# Authorized Field Change

AFC G-05903 Revised

**Subject:** 5000i and 9000i Models with Cummins ISX Engines Built at the Chatham and Garland Assembly Plants Between November 6, 2002 and April 1, 2004 and 9000i Models Built at the Escobedo Assembly Plant Between November 6, 2002 and October 18, 2004 Require Replacing the Fan Hub Mounting Fasteners and Tighten to New Specification

**Figure 1 Replace Fan Hub Mounting Bolts**

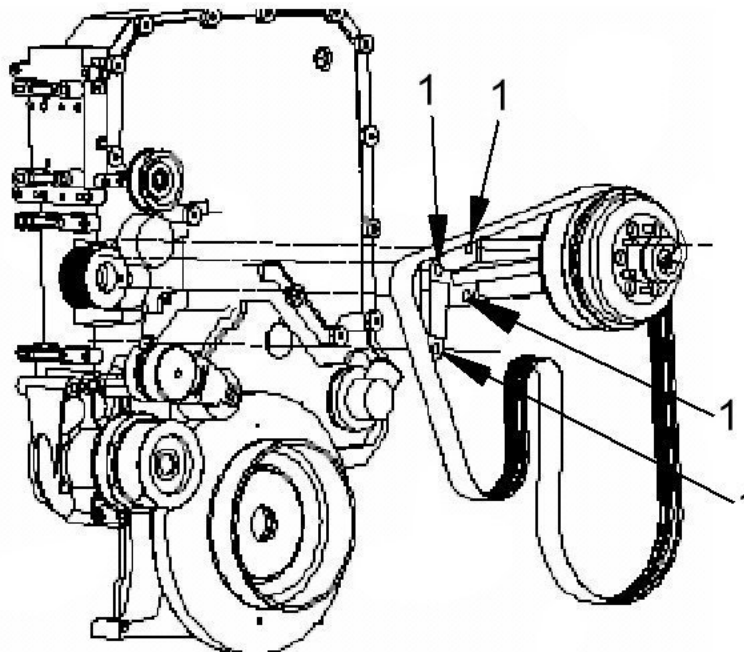
The vendor recommended torque specification is not adequate for the fan hub mounting bolts. It is possible the fan hub mounting bolts may loosen resulting in fan and radiator damage.

Refer to Figure 1

1. Remove the tension from the fan belt.
2. Remove **one** hub mounting bolt and replace with the equivalent bolt from the kit. Turn the bolt until the bolt flange is in contact with the hub flange.
3. Repeat the procedure for the three remaining bolts.
4. Tighten the fan hub mounting bolts to 80 to 100 Lbf-ft (108 to 136 Nm).
5. Re-install the fan belt.
